PCN# 20121203001

Correct RGMII transmit packet corruption,
USB in-rush current,
HDMI SDA/SCL pins on

MityARM-335x Development Kits

PCN Number: 20121203001
PCN Date: December 3, 2012
Title: Correct Transmit Packet Loss, USB inrush, HDMI DDC lines
Contact: Bill Halpin
Phone: (315) 425-4045
Ship Date: 03/01/2013

Figure 1 RGMII Transmit Data Path, Prior to Change

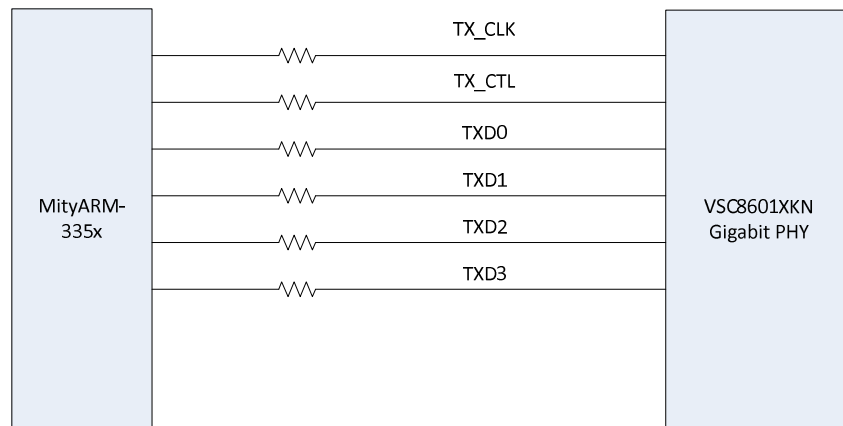
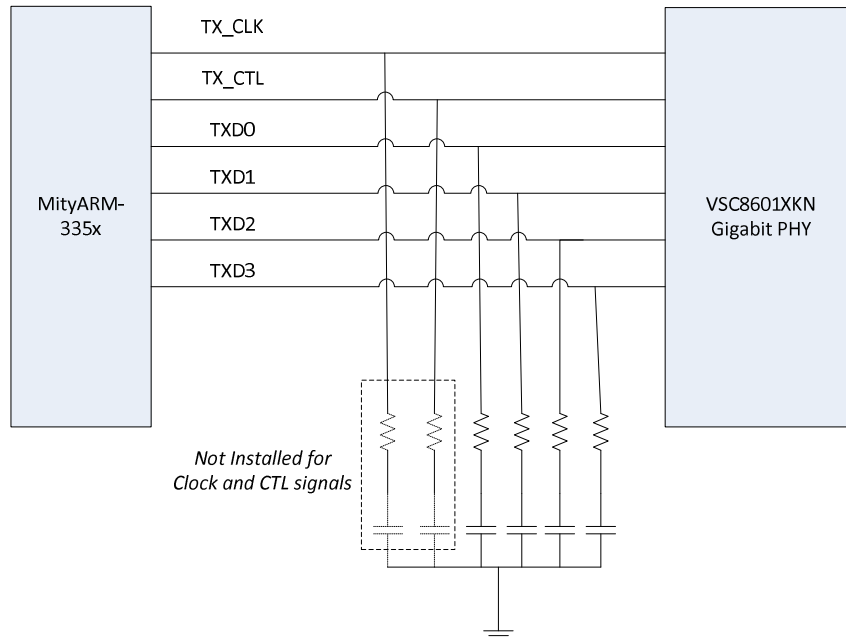
The signal termination for the RGMII data lines on the MityARM-335x development kit board has changed from series termination (see Figure 1) to R/C termination (see Figure 2) in order to improve the signal integrity margins and cross talk between the data lines and the RGMII transmit clock and data valid signals. In addition, the TX_CLK line was isolated from the data lines on the PCB layout.

Prior to the change, certain data patterns (for example, a packet containing all “0xF0” octet codes) transmitted from the MityARM-3359 SOM over the RGMII interface to the gigabit Ethernet PHY on the development kit host board could result in packet corruption and failed transmission. The packet corruption was due to signal cross talk to the transmit clock and control lines as well as a small amount of impedance mismatch on the data lines. The data corruption was only observable at low statistical rates when 3 or 4 data lines toggled simultaneously over large packet sizes. Patterns such as 0xF0, which transmitted as nibbles along the RGMII interface resulted in “bit-bang” style data patterns, were used to detect the error condition.

This change resolves the packet corruption, providing the capability to transmit packets without sensitivity to the data payload.
